CERTIFICATE OF APPROPRIATENESS PLACARD

Changes to COA-0014-2019 (porch alterations, exterior stair alteration, add basement door and covered entry);
Renew COA-0014-2020

407 N Blount St

Summary of Work- Certificate of Appropriateness Major Works application, Revised for Minor Works 6-23-2020

407 N. BLOUNT STREET PROPOSED BASEMENT PLAN
SCALE: 3/32" = 1'-0"

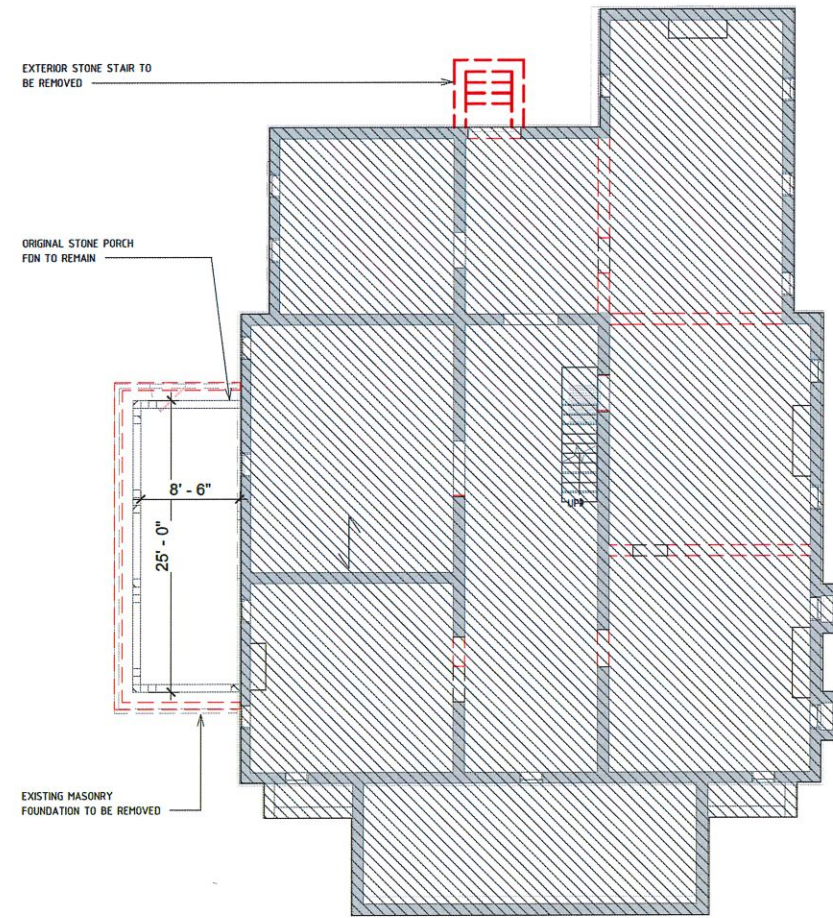
An existing, non-original addition is to be removed along with its brick foundation walls on the south elevation. The cut stone foundation of the original side porch is intact inside the newer brick foundation, and will be retained. Rebuilding a small addition on the existing cut stone foundation in this location is proposed. The design for the addition is based on a documentary image of the original porch and matches the existing porch details on the east elevation, see attached. A covered porch is proposed off of the south addition at the southwest corner of the building. Modifications have also been made to the west elevation of the building. The National Register nomination references a porch on the rear or west elevation similar to the porch on the front or east elevation. A door has been converted to a window (although the original architraves remain) and wooden stairs have been added to provide access to a first floor door. A separate set of wooden stairs provides access to a second floor door. The stairs and landings are to be removed. An exterior entrance to the basement is located under this deck and will also be removed. A new exterior concrete stair will be built in its place to accommodate access to a lowered basement floor *with a covered metal roof.*

3.2.8 The new addition on the south elevation is located where the original side porch was located, and the intent is to rebuild on the existing cut stone foundation of the original porch. The new exterior stair is located where the existing stair is located but has to be enlarged to accommodate more stairs to a new basement finish floor and meet building code and egress requirements. ***A new door will be installed at this basement entrance.***

407 N. BLOUNT STREET TREE PROTECTION DIAGRAM
SCALENTS

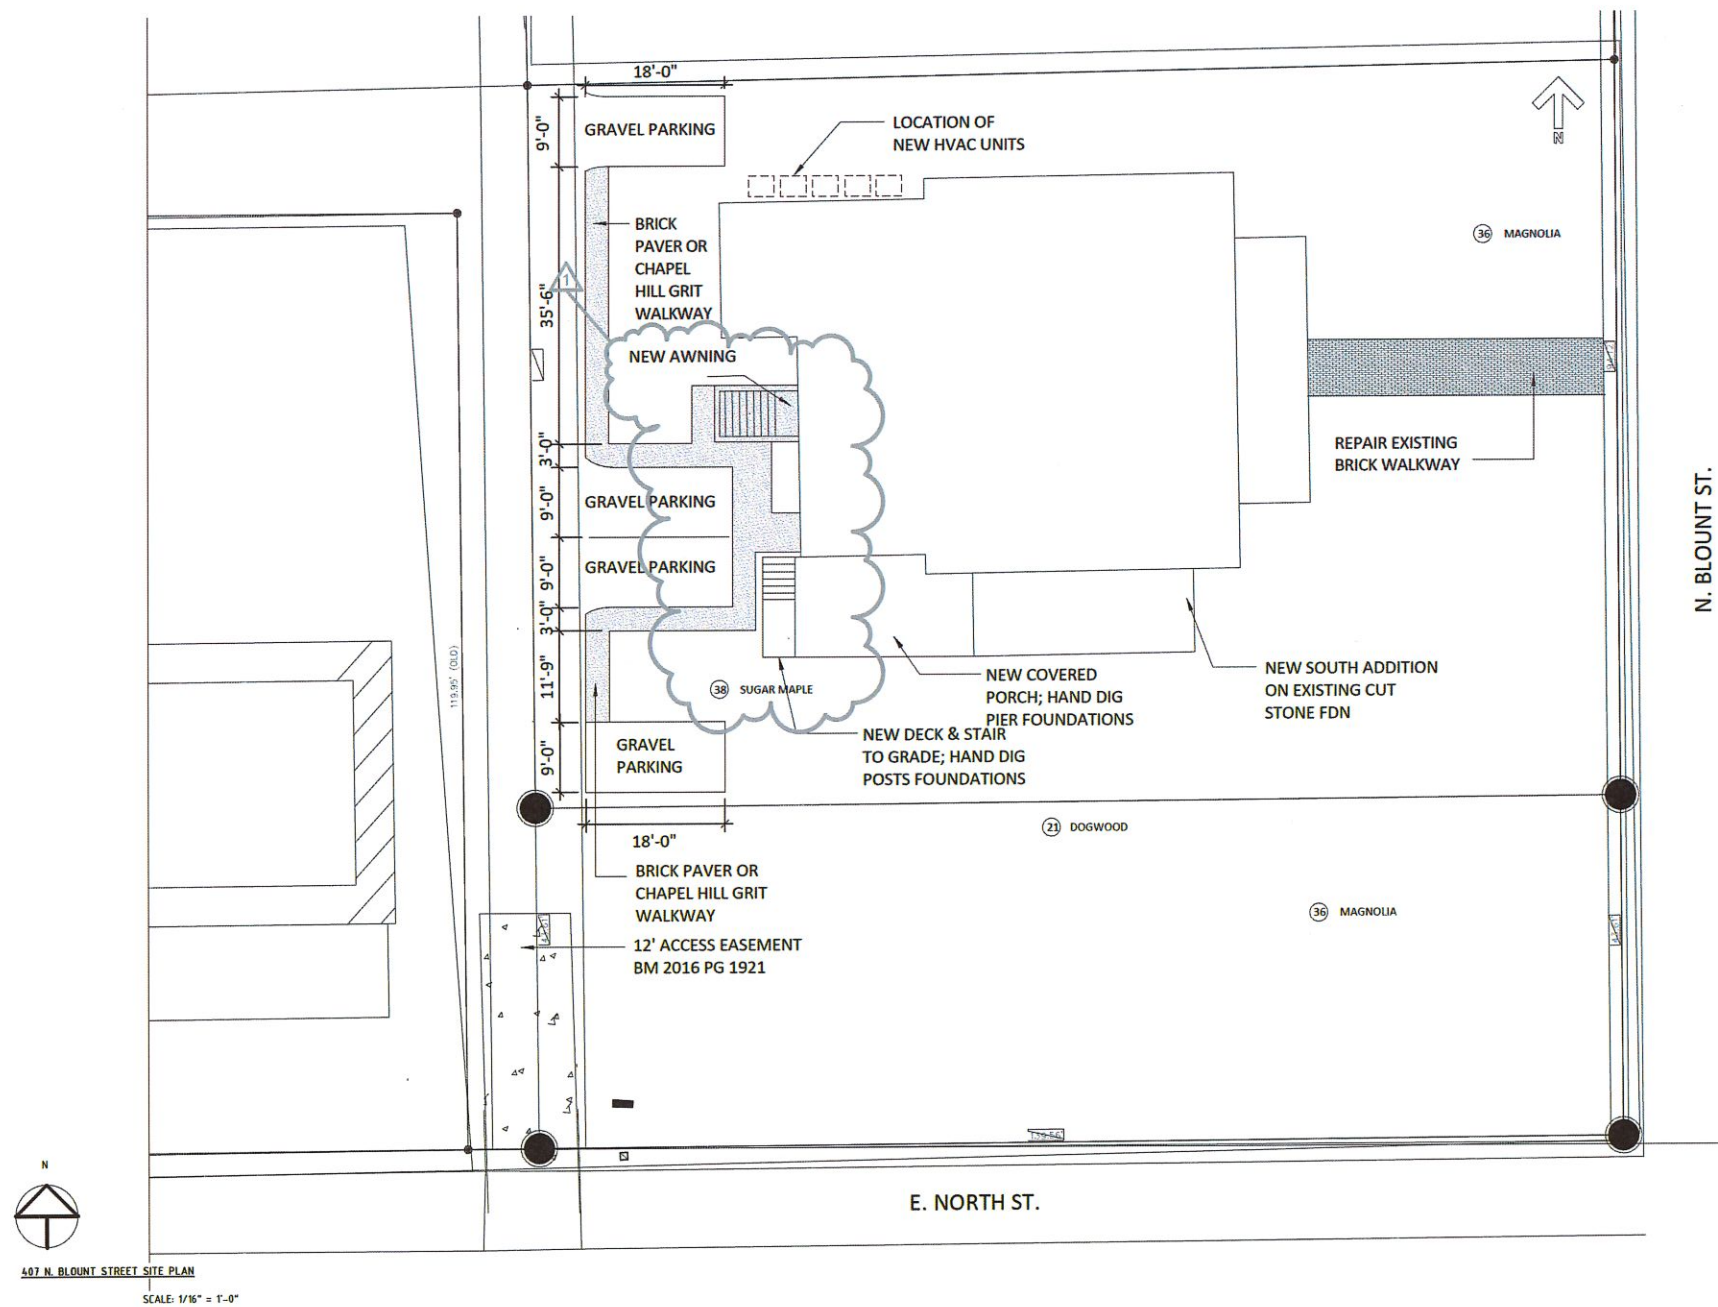
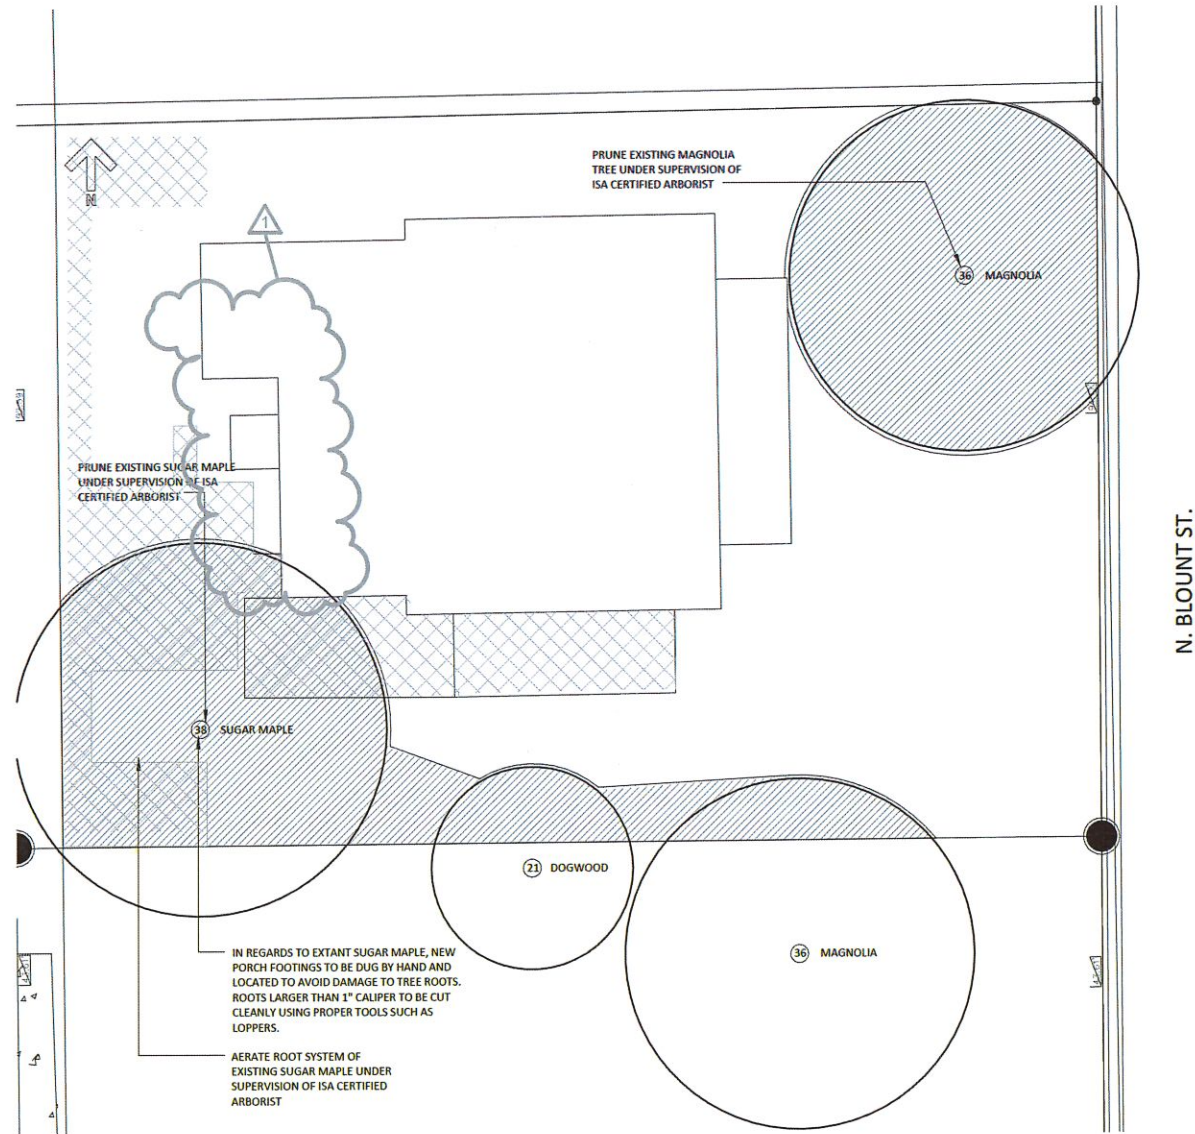
3.2.4-3.2.5 A tree protection plan is included that shows the critical root zone for individual trees to be retained and the location of tree protection fencing. There is a mature oak tree in close proximity to the building; due to the location of the existing parking area, the soil has likely been compacted within the critical root zone of this tree. In the material choice of gravel for the enlarged parking area and with the intention of hand digging to

excavate for the new covered porch pier foundations, the future owners plan to retain this tree and protect it during construction activities.
